Alpine Street
Garage

11-15 ALPINE STREET
SOMERVILLE, MA

REVISION TO ZBA 2016-75
September 30, 2021

List of Changes; Refer to Accompanying Narrative.

Left Side Elevation

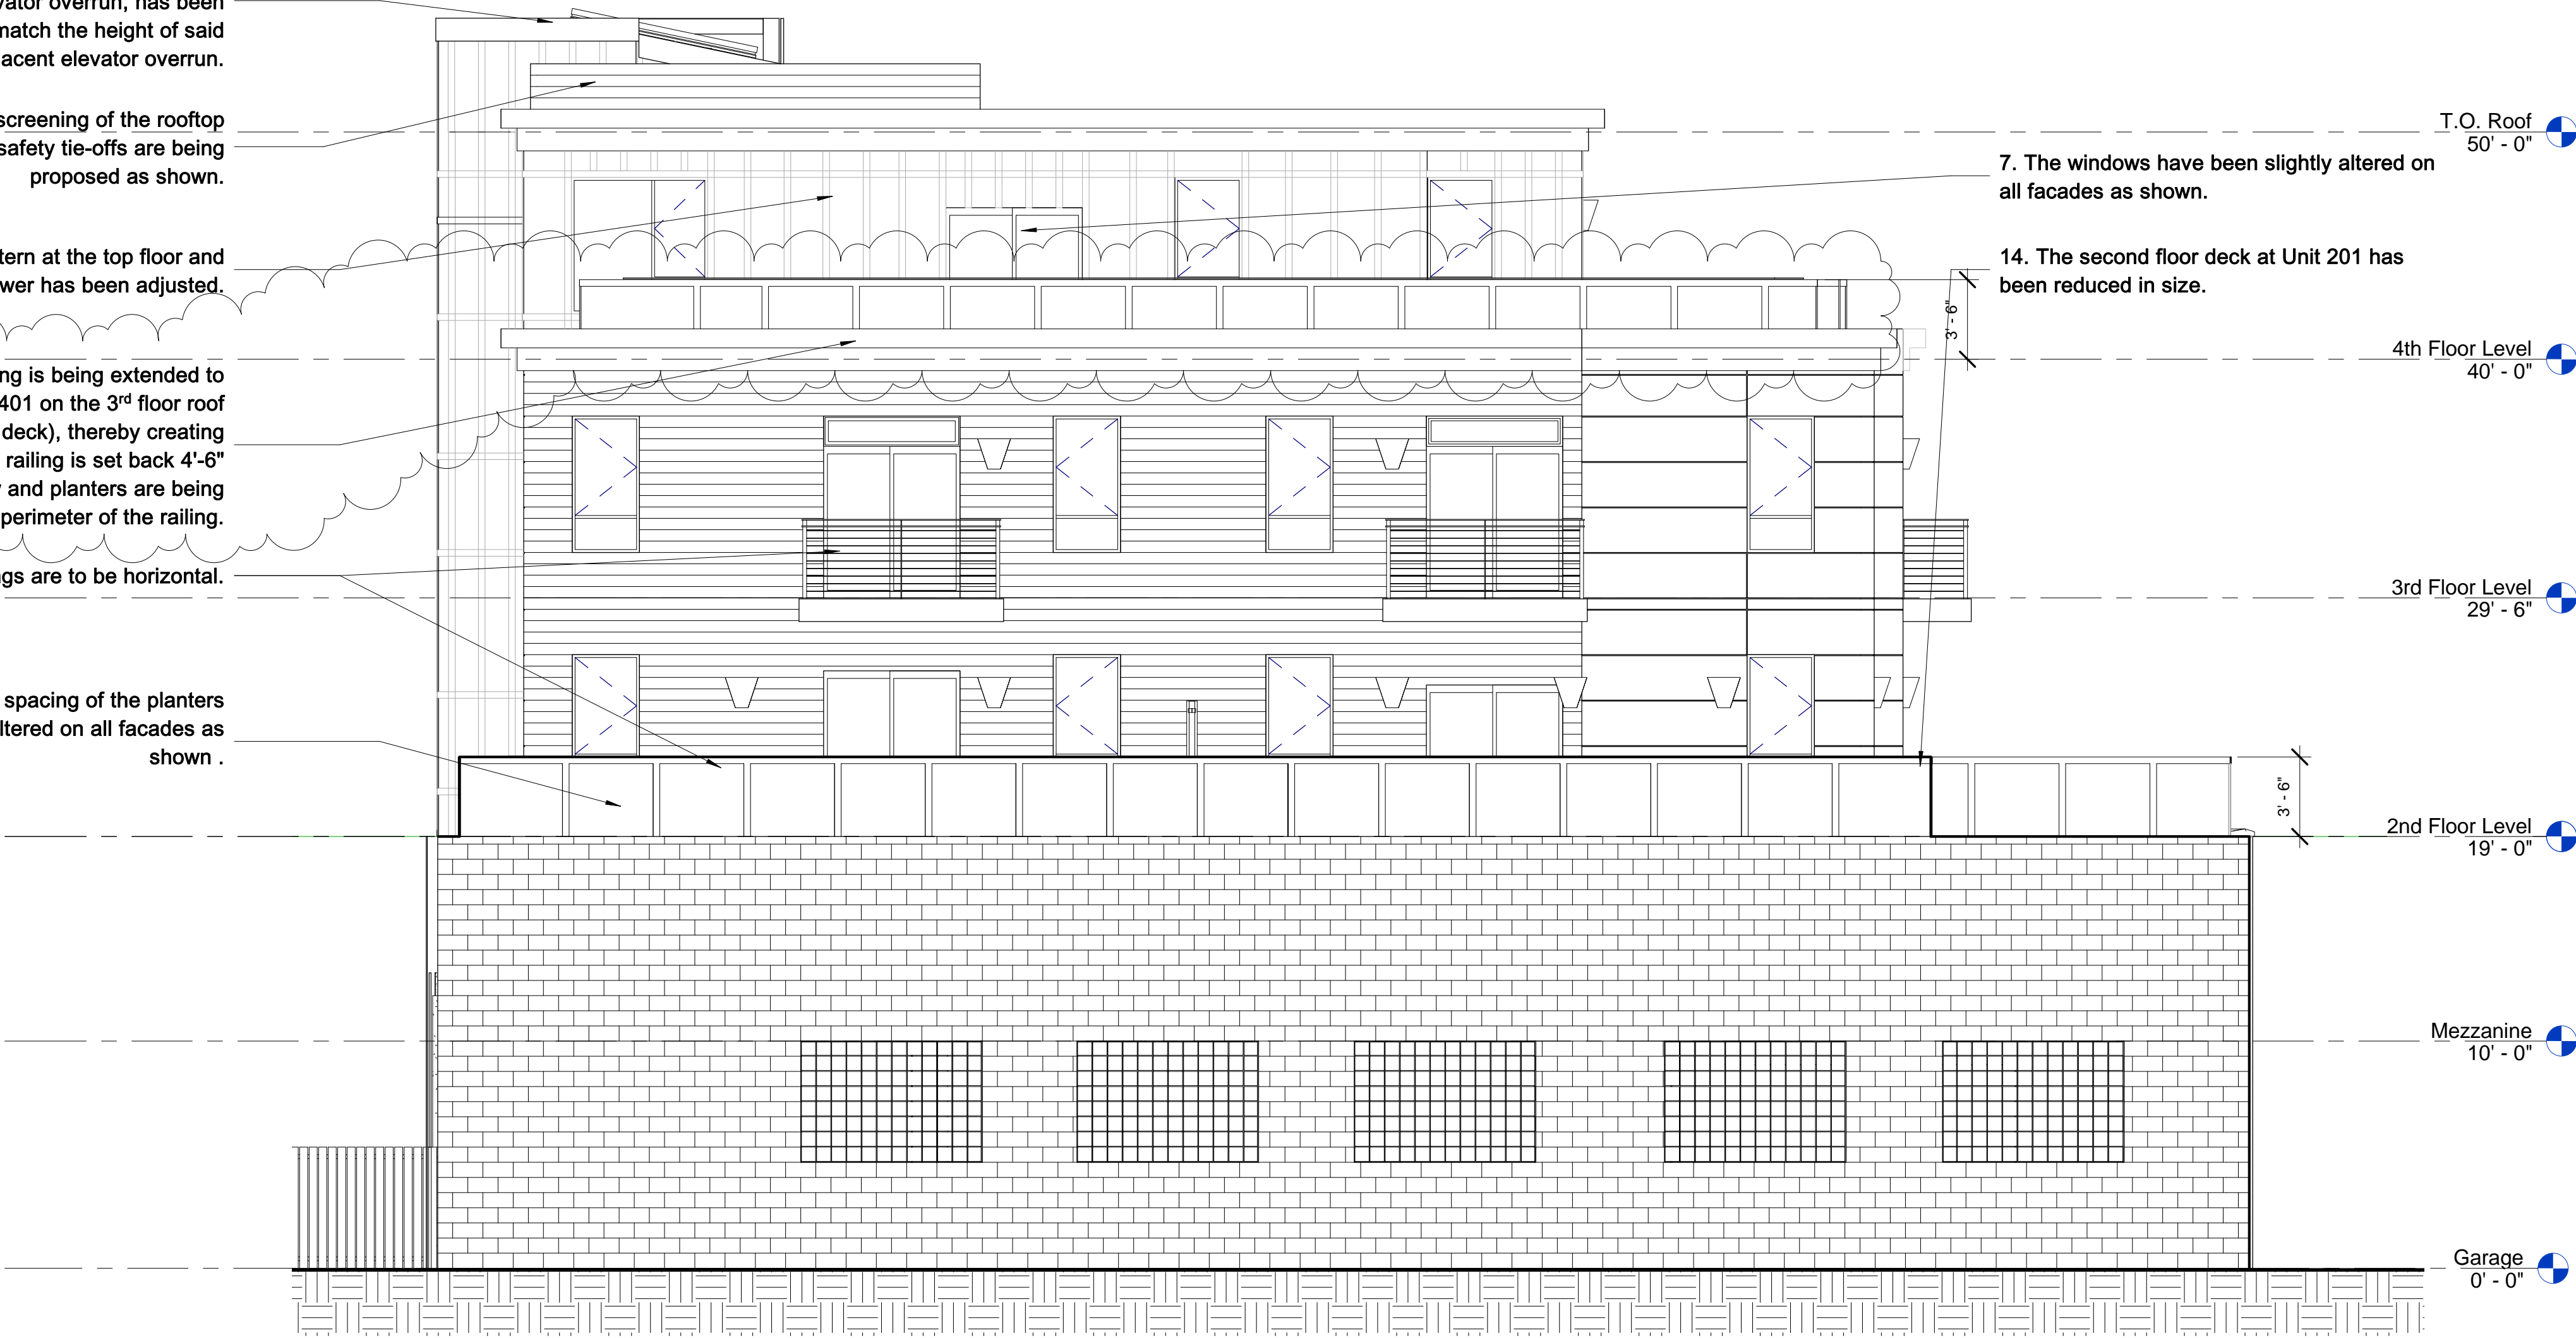
10. Cedar screening of the rooftop mechanicals with safety tie-offs are being proposed as shown.

2. The batten pattern at the top floor and right-side stair tower has been adjusted.

9. The iron railings are to be horizontal.

7. The windows have been slightly altered on all facades as shown in the elevations.

5. CMU block is to be used on the Easterly wall.
